# Access Compliance Report

## Public Rights-of-Way

### (Curb Ramps)

Intersection ID: N/A	Main Street: SAWMILL_TRACE_DR	Cross Street: WHITE_MOON_CT	Location: N
ADA ID: 9DF9E892C3E4	Ramp Type: Combination1Diag	Initial Pass/Fail: Fail	Overall Compliance: No
			Severity Score: 0

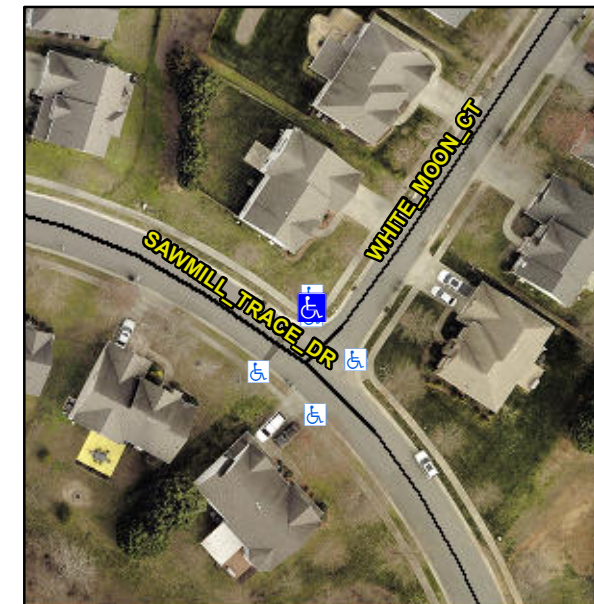
**Not Found, R304.5.1, R304.5.1, R304.2.2, R304.5.3, R304.3.2**

Compliance	Description	Data	Compliance	Description	Data
N/A	Ramp Length LT (in)	37.0	N/A	Ramp Length RT (in)	26.5
No	Ramp Width LT (in)	46.5	No	Ramp Width RT (in)	46.5
No	Ramp Slope LT (%)	9.0	No	Ramp Slope RT (%)	9.2
No	Ramp XSlope LT (%)	3.0	No	Ramp XSlope RT (%)	3.1
N/A	Ramp Length (in)	45.5	No	Ramp Slope (%)	9.0
No	Ramp Width (in)	39.0	No	Ramp XSlope (%)	5.8
N/A	Flare Type LT	N/A	N/A	Flare Type RT	N/A
N/A	Flare Slope LT (%)	N/A	N/A	Flare Slope RT (%)	N/A
N/A	Flare Traversable LT?	N/A	N/A	Flare Traversable RT?	N/A
N/A	Landing Length (in)	N/A	N/A	DWS Provided?	N/A
N/A	Landing Width (in)	N/A	N/A	DWS Contrast?	N/A
N/A	Landing Slope (%)	N/A	N/A	DWS Length (in)	N/A
N/A	Landing X Slope (%)	N/A	N/A	DWS Full Width?	N/A
N/A	Landing Curb? (Y/N)	N/A	N/A	DWS Offset (in)	N/A
N/A	Shared Landing?	N/A			
N/A	Gutter Ponding?	N/A	N/A	Gutter Slope (%)	N/A
N/A	Gutter Lip Ht (in)	N/A	N/A	Gutter X Slope (%)	N/A
N/A	Painted X Walk1?	No	N/A	Painted X Walk2?	No

**Remove & Replace Curb Ramp With Two New Directional Ramps or Equivalent.**
